Subject: VIRGIL C. SUMMER NUCLEAR STATION
DOCKET NO. 50/395
OPERATING LICENSE NO. NPF-12
TECHNICAL SPECIFICATION AMENDMENT REQUEST
TSP 00-0032 REVISION TO ENGINEERED SAFETY
FEATURE ACTUATION SYSTEM INSTRUMENTATION
TABLES

SCE&G -- EXPLANATION OF CHANGES

TABLE 3.3-3 (Continued)

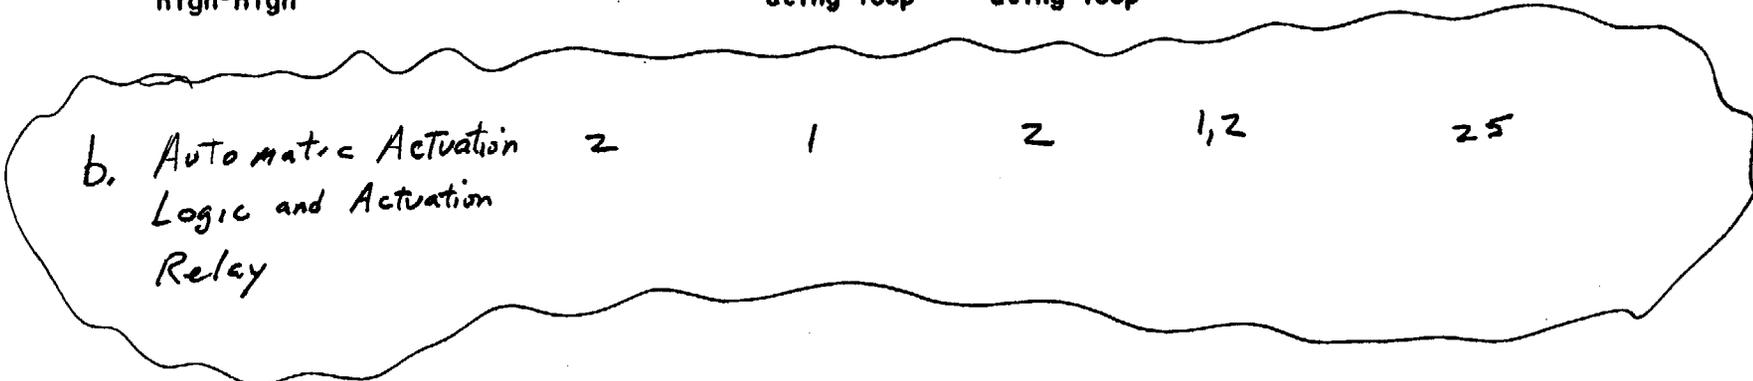
<u>Page</u>	<u>Affected Section</u>	<u>Bar #</u>	<u>Description of Change</u>	<u>Reason for Change</u>
3/4 3-20	Table 3.3-3	1	Added Functional Unit 5.b., "Automatic Actuation Logic and Actuation Relay" to TURBINE TRIP AND FEEDWATER ISOLATION Unit.	Determined that Table 3.3-3 will be conservatively considered to include Functional Unit 5.b., to provide consistency with Tables 3.3-4 and 4.3-2, similar to NUREG 1431, Revision 1.
3/4 3-23	Table 3.3-3 Action Statement 16	1	Adding Allowed Outage Time to Action 16.	LER 2000-004-00 commitment.
	Action Statement 19.b	2	Removed "s" from requirement.	Typographical error made in original issuance of TS.
3/4 3-24	Action Statement 24	1	Removed "s" from requirement.	Typographical error made in TS Amendment 101.
	Table 3.3-3	2	Added ACTION STATEMENT 25 to describe action for inoperable channels of Functional Unit 5.b.	Same reason for change as Page 3/4 3-20 above.

Handwritten mark

Handwritten mark
